Questions / Answers

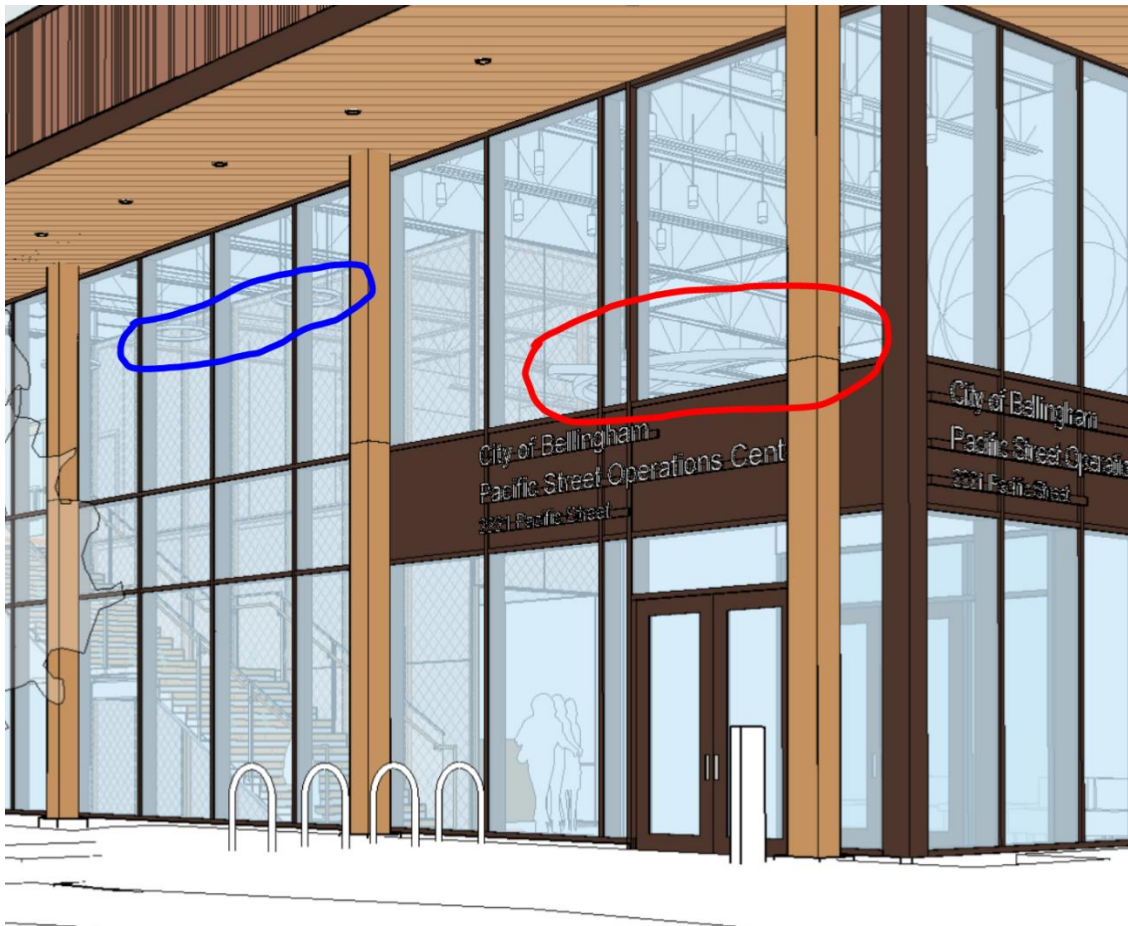
- Are the "Halo" lights over the stairs shown in the model the actual fixtures or just placeholders (circled in blue below)? If they are real, can they be moved or should we consider them fixed?

They are fixtures but the architect can work with the artist on placement. There are lighting requirements per the code

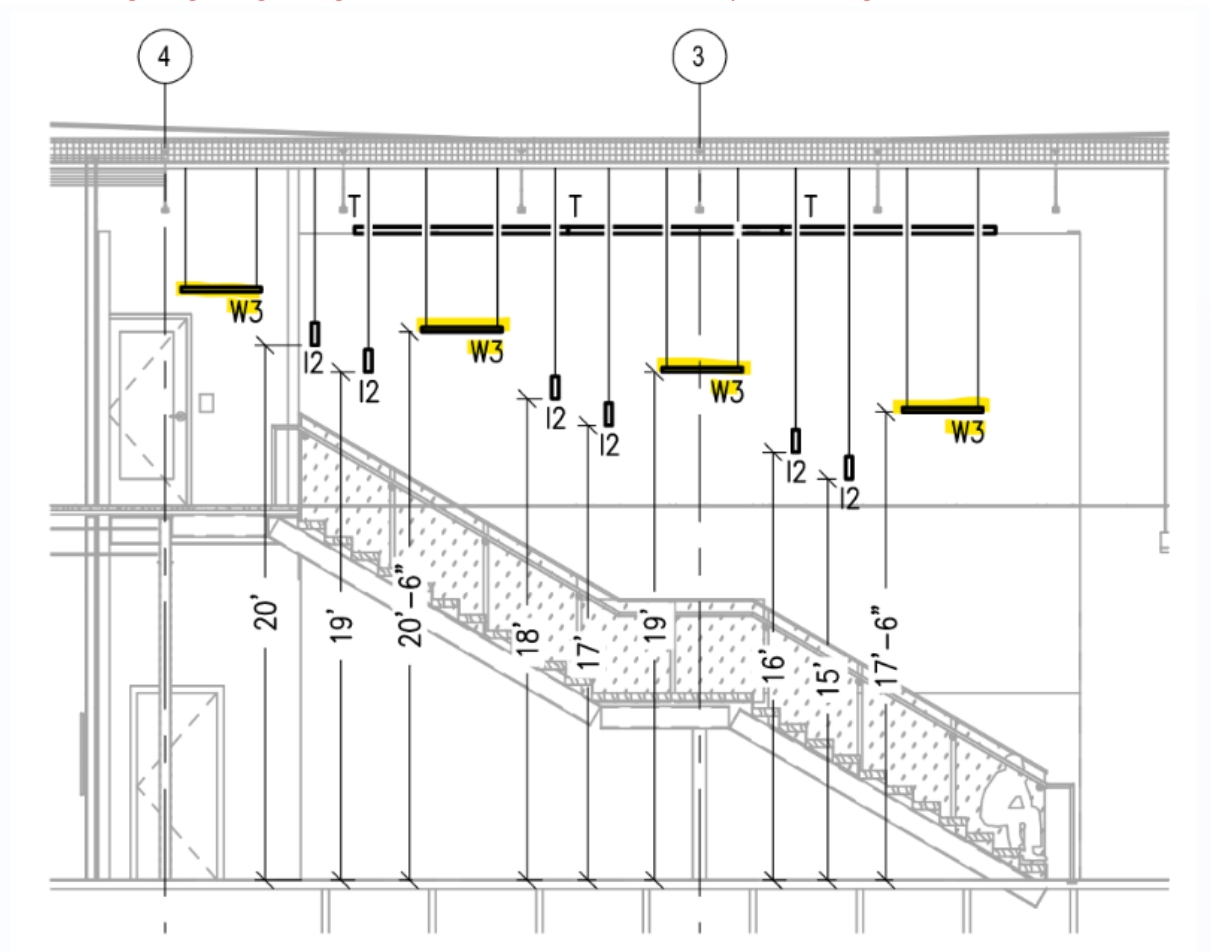
- The defined space for the hanging sculpture does not go into the space above the stairs. Would it be possible to propose a work that does go into the space above the stairs (as long as it is out of reach?)

Yes, they may drift over into this zone, with the one caveat that they need to work around the lighting in that area (the stair lighting is needed for code, we can't delete). See below. I will email our lighting designer right now to see if there is flexibility in the heights...

4 East Elevation - Building Sign

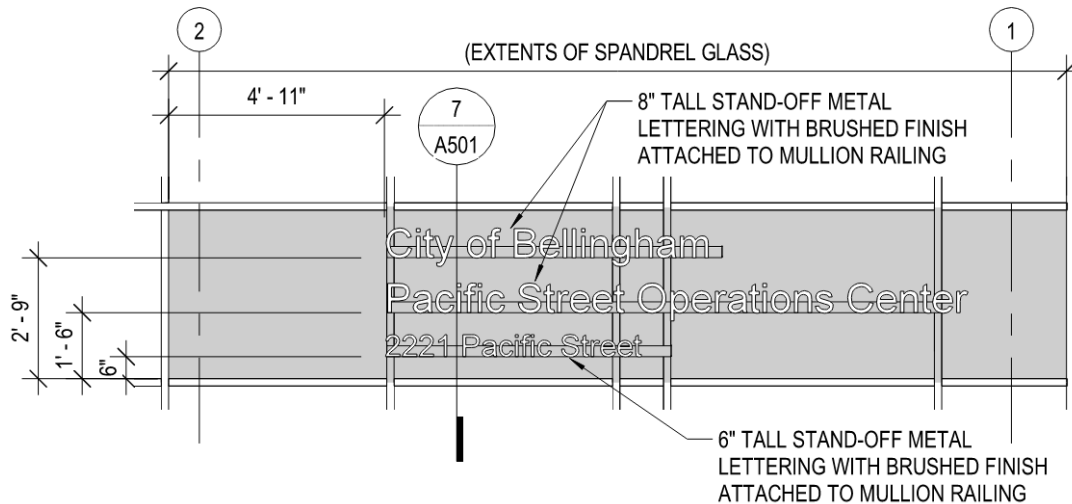
- What is the design of the sign above the door? i.e. material and color?

Here is the address sign, with materials called out. Brushed metal finish/color:
